# Priority Development Project (PDP) Storm Water Quality Management Plan (SWQMP)

This Drainage Study presents a revision to the September 10 study pursuant to first LDR-Engineering review comments from the City of San Diego. The following text is the City of San Diego's plan check comments (in italicized lettering), immediately followed by Rick Engineering Company's responses.

**PRIORITY DEVELOPMENT PROJECT (PDP)  
STORM WATER QUALITY MANAGEMENT PLAN (SWQMP)  
FOR  
ONE ALEXANDRIA NORTH  
REVISION PAGE  
September 10, 2021**

**DMA Exhibit**

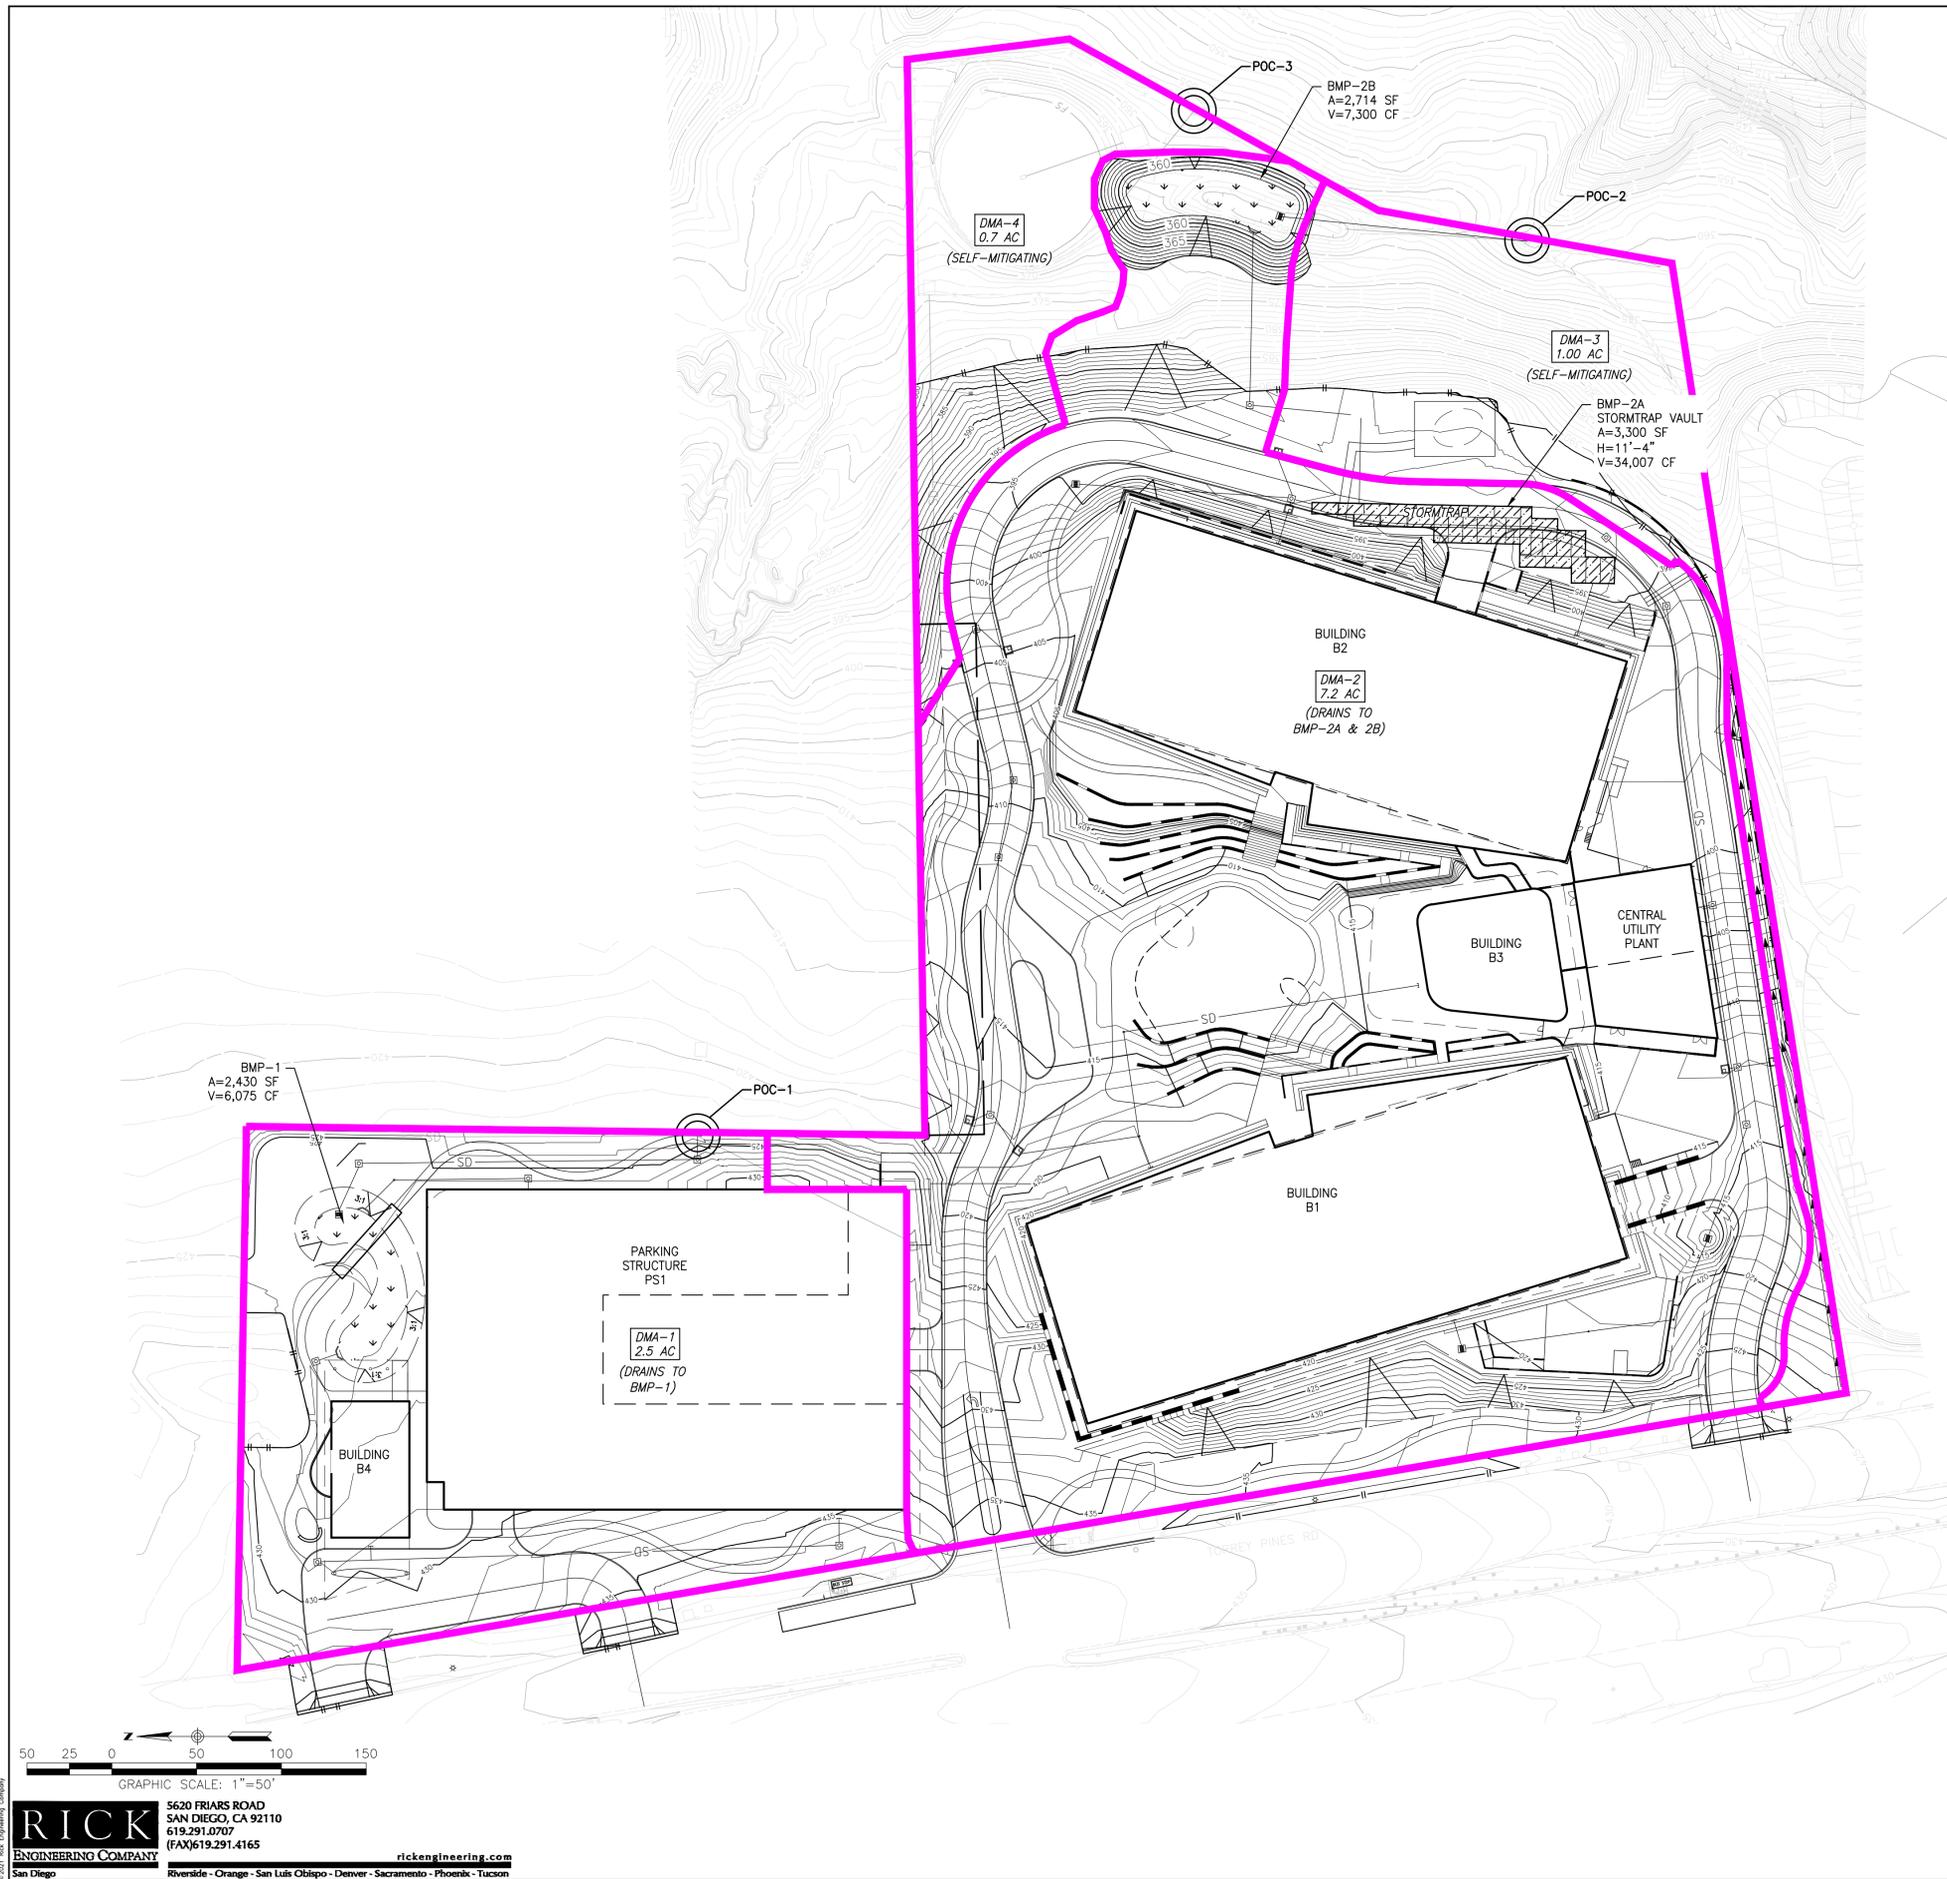
- 34. Please revise plans and DMA Exhibit to callout basin size and volume as stated in submitted SWQMP.*

- 37. Please revise plans and DMA exhibit to show and call out proposed "Storm Trap" system. Please be sure to call out size and volume on plans and exhibit. Please also clarify if applicant is proposing this system for hydromodification purposes.*

34. *Please revise plans and DMA Exhibit to callout basin size and volume as stated in submitted SWQMP. (New Issue)*

35. *DMA Exhibit: Provide structural details and cross sections of all proposed Treatment Control BMPs on the DMA Map. (New Issue)*

37. *Please revise plans and DMA exhibit to show and call out proposed "StormTrap" system. Please be sure to call out size and volume on plans and exhibit. Please also clarify if applicant is proposing this system for hydromodification purposes. (New Issue)*

**A callout on the DMA exhibit has been added to provide additional information about the "StormTrap" system. Notes have been added for size, storage volume, and HMP.**

Comment noted and addressed.

The proposed proprietary pollutant control BMP details and cross-sections have been included separately in Attachment 1E. BMP cross-section detail of the proposed biofiltration BMP however has been included in the DMA exhibit as requested.

Comment noted. Call out for the stormtrap system size and volume has been added to the DMA exhibit. Please note that the Notes provided in the DMA exhibit as well as Form I-6 in the report already discusses clearly that DMA-2 uses cistern to biofiltration for both HMP and pollutant control.
